REQUEST

Current Zoning: MUDD-O (mixed use development, optional)
Proposed Zoning: MUDD-O SPA (mixed use development, optional, site plan amendment)

Approximately 2.58 acres located on Carnegie Boulevard, near Torp Landing Boulevard and Charmeck Palisades Drive, west of Barclay Downs Drive.
(Council District 6 - Bokhari)

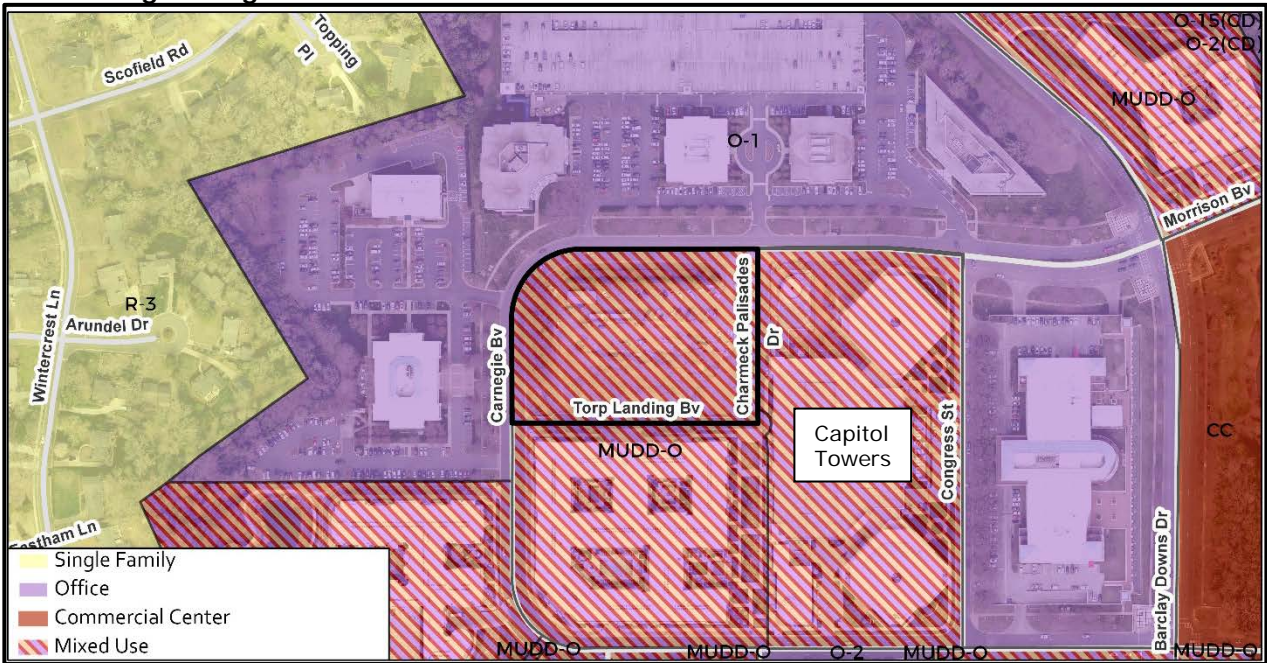
1. ~~Amend the building perspective views to annotate key architectural design elements committed to as part of the rezoning.~~ Addressed.

6. ~~Add a note to the Carnegie Street Elevation and the third Perspective View graphics to clarify the intent of the graphics is to show relationship to existing surrounding development.~~ Addressed.
